Great North Road Solar and Biodiversity Park

Draft Statement of Common Ground with National Highways

Document Reference – EN010162/APP/8.6

December 2025

Project:
AADT CONSTRUCTION TRAFFIC FLOWS ON A1
WORST CASE (100% Route North AND 100% Route South)

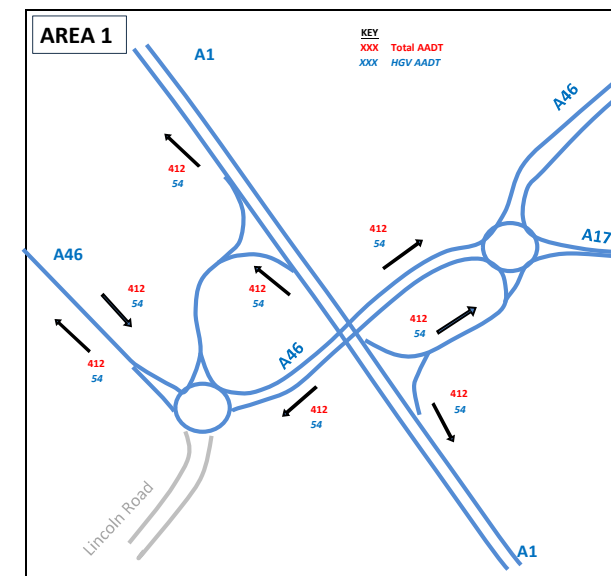
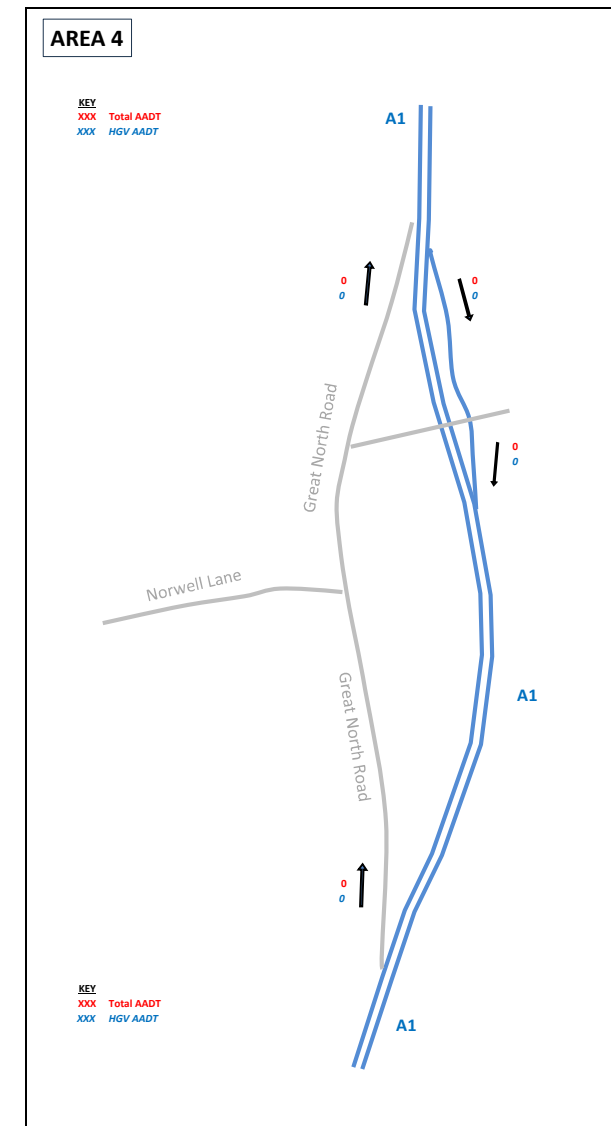
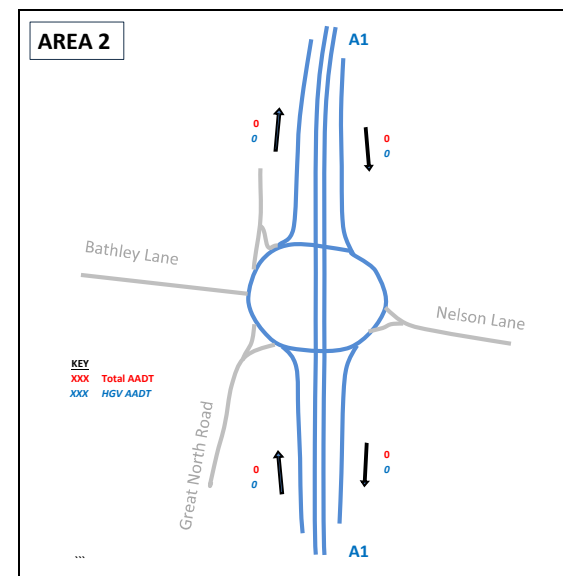
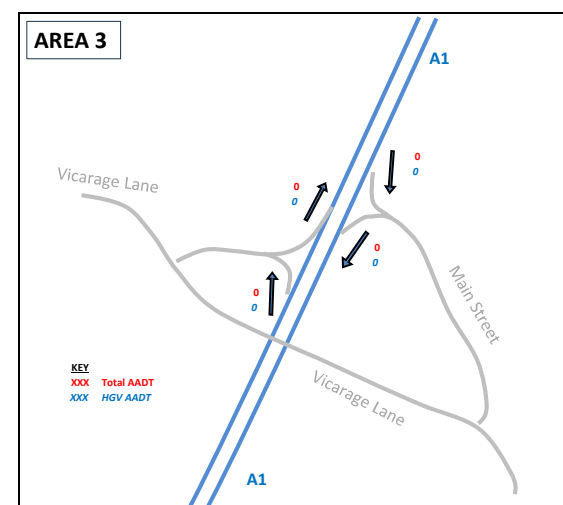
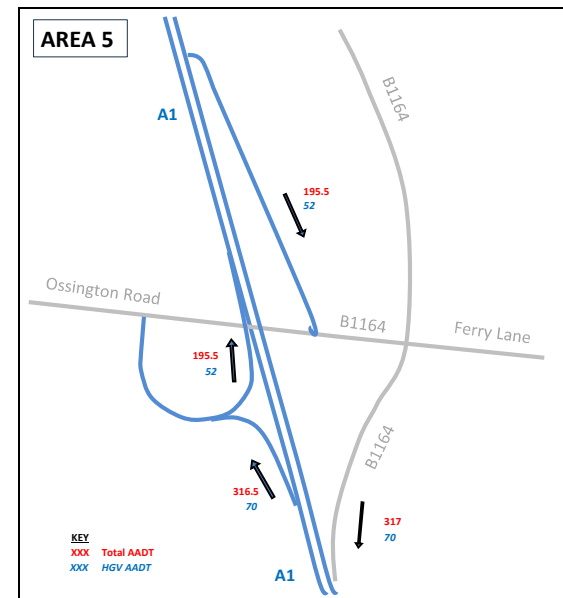
2.1.5		Trip Distribution	The Applicant is content to provide this information, which will be included at Deadline 1. These diagrams will show the traffic flows currently presented in Appendix 1 of this SoCG.	National Highways requests that flow diagrams for construction traffic are provided for our review. When this has been provided, we will be in a better position to comment on the traffic impact of the proposed development.	Under Discussion
